RE: DA/1157/2016 – 657-661 VICTORIA ROAD & 4-6 WHARF ROAD MELROSE PARK NSW

This is a joint submission prepared by Allen Jack + Cottier (AJC) and KEYLAN Consulting (KEYLAN) on behalf of PAYCE in relation to the above Development Application currently under consideration by the Sydney West Central Planning Panel. This submission specifically addresses the proposed *Part A Concept Plan Conditions, Condition 4 - The Approved Building Envelopes* of the Draft Development Consent.

Melrose Park Avenue

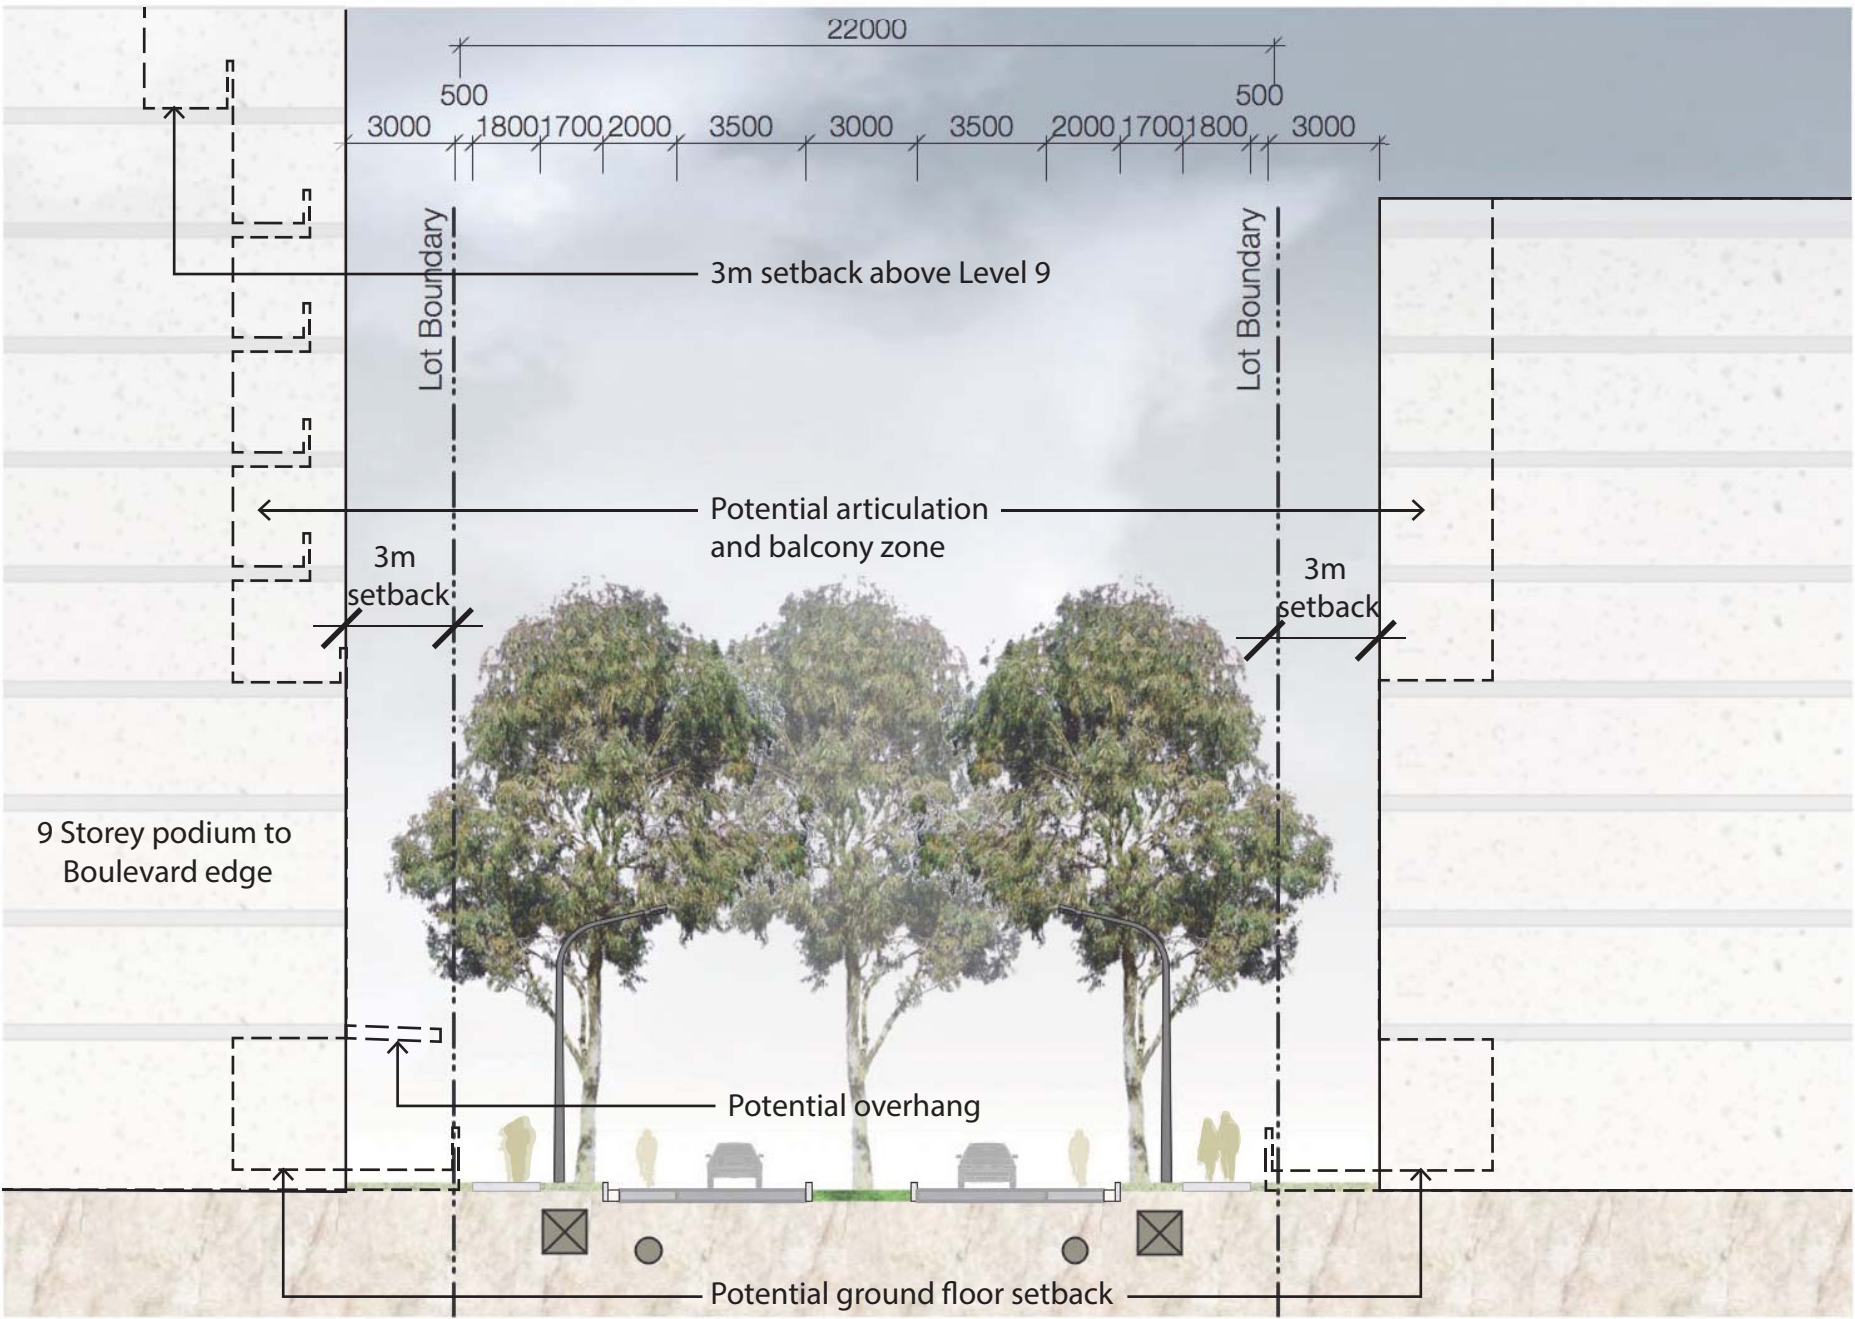
The Masterplan and typical street sections show a consistent 3m building setback (see attached Avenue section) which demonstrate the provision of ample pedestrian amenity.

MELROSE PARK - TYPICAL ROAD SECTION:
 NSR-2 AT JUNCTION VICTORIA ROAD
 30.3 m WIDE STREET WITH 3m SETBACKS
 Scale 1:100

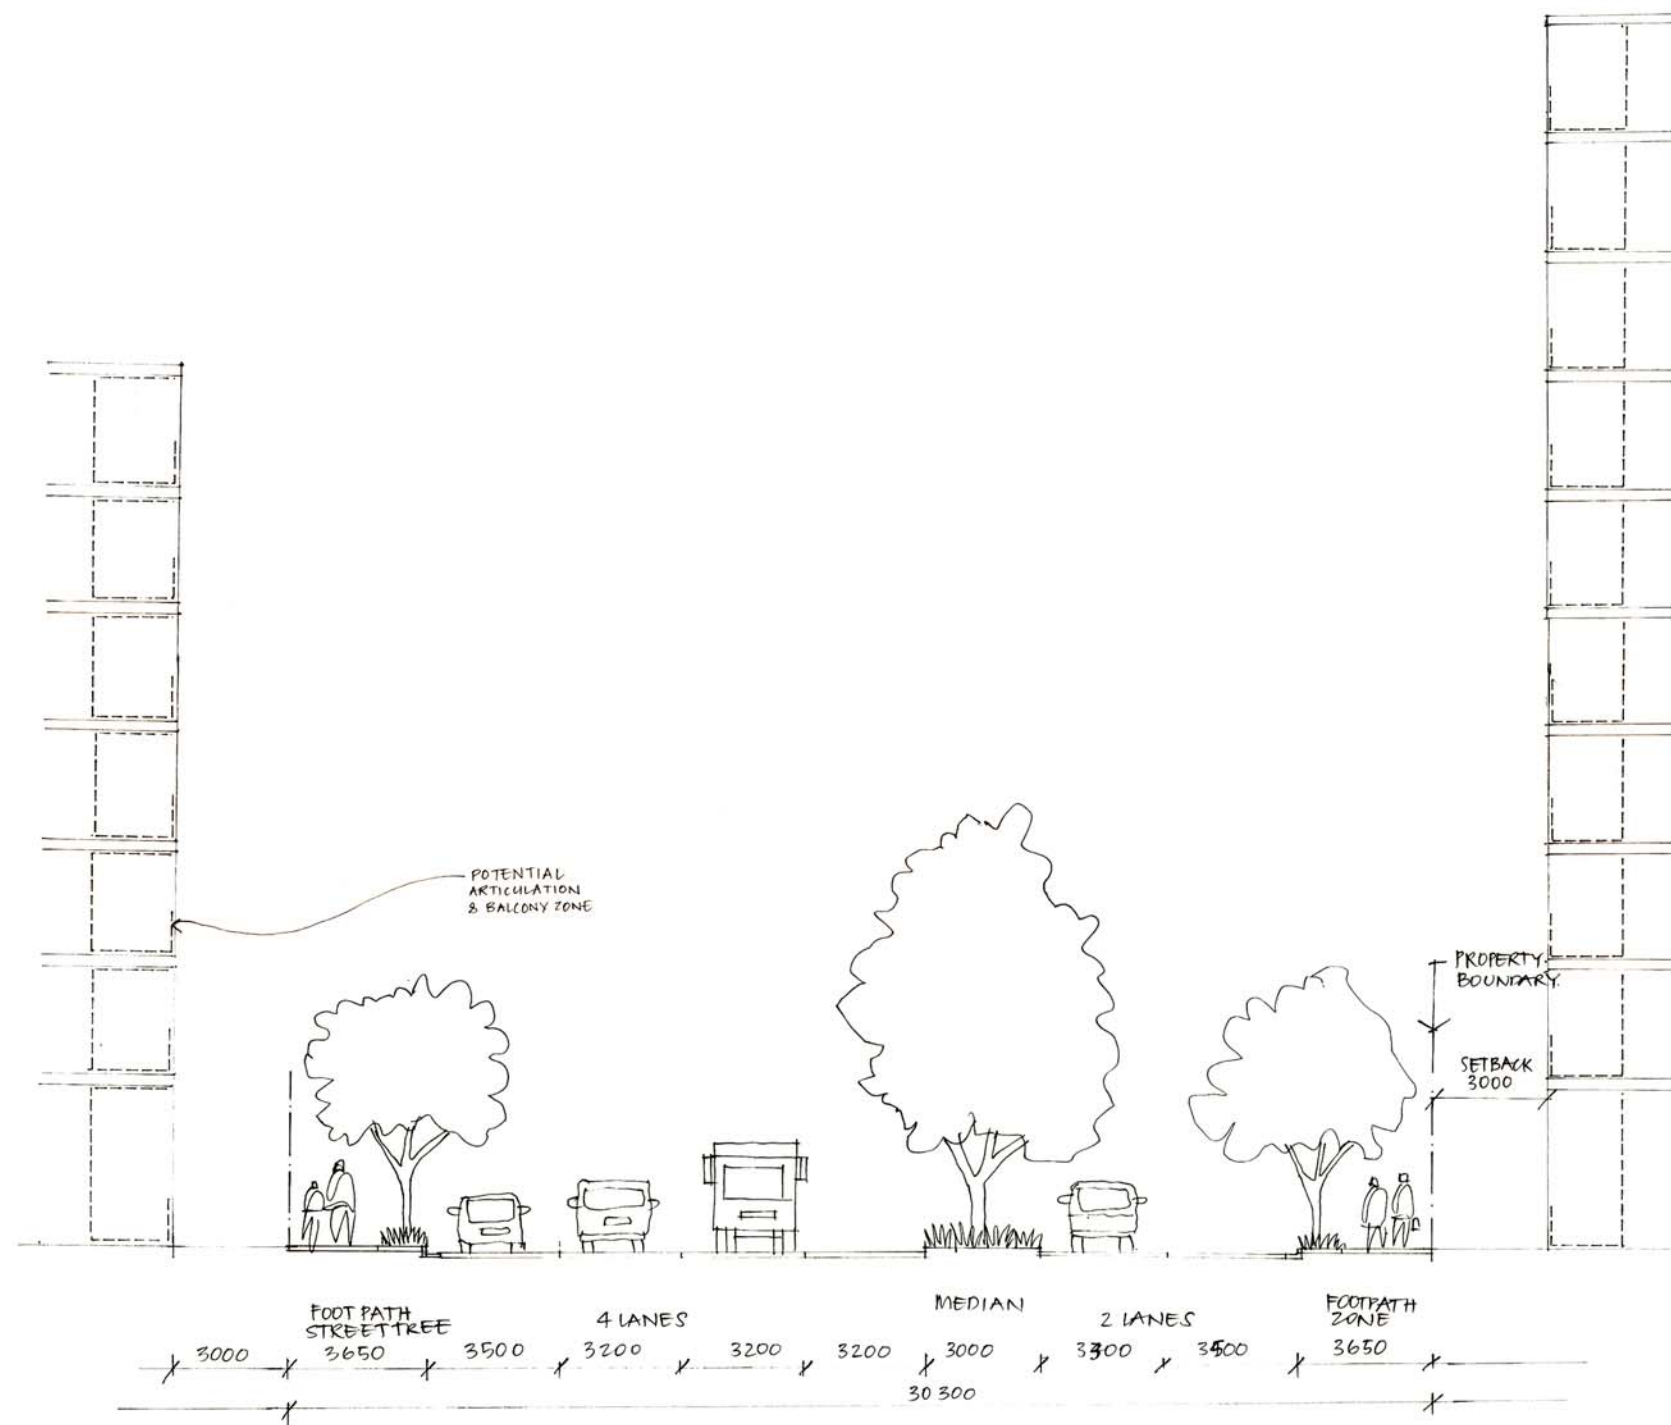
This urban design outcome is entirely consistent with the Masterplan to the south, which adopts a minimum 3m building setback for all streets. The proposed minimum 3m building setback will result in ~36m width between buildings – see attached NSR-2 road section.

Increasing the minimum building setback to 5m would result in a minimal increase in the overall road width (~10%). In this instance, the ~40m width between buildings would be approximately twice as wide as a local street and would be inconsistent with an orderly hierarchy of road types and widths.
